## DS-K1T341A Series MinMoe Terminal Release Notes (2021-11-15)

<b>Device Model:</b> DS-K1T341AM DS-K1T341AMF	Firmware Version	ARM: ACS_641_AI3_EN_STD_V3.2.30_build211110 ACS_641_AI3_EN_NEU_V3.2.30_build211110
	SDK	Latest version
<b>Naming Rule:</b> M for M1 card, F for fingerprint	iVMS-4200 Client Version	Latest version baseline

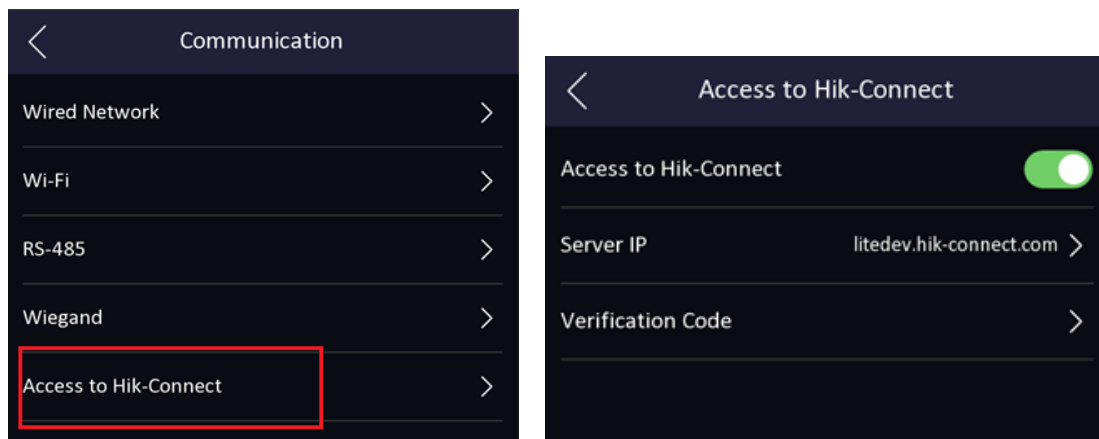
1. Add Hik-Connect menu in device UI Menu→Comm. The function is disabled in default.

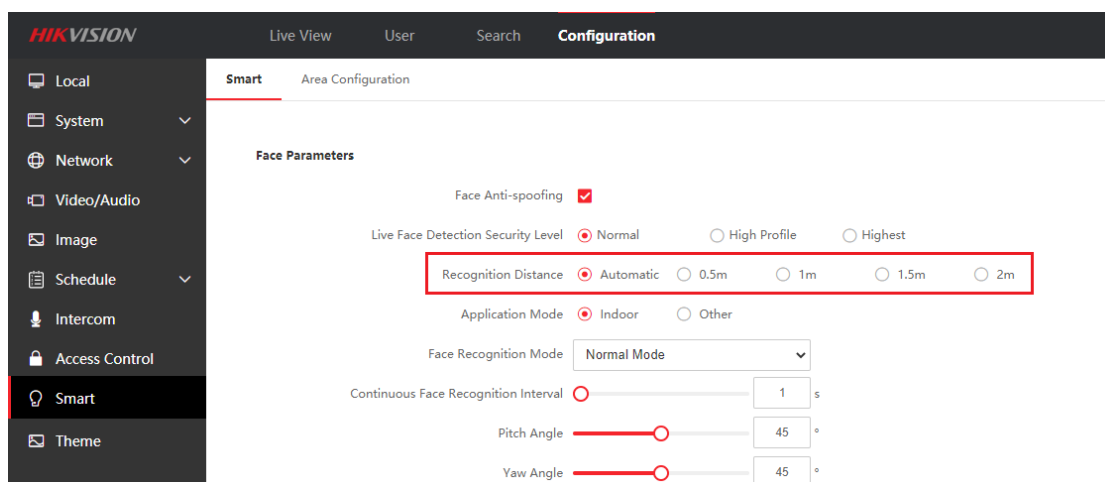
1. Optimize the wake-up distance of the device screen through the face, and the wake-up distance is consistent with the recognition distance
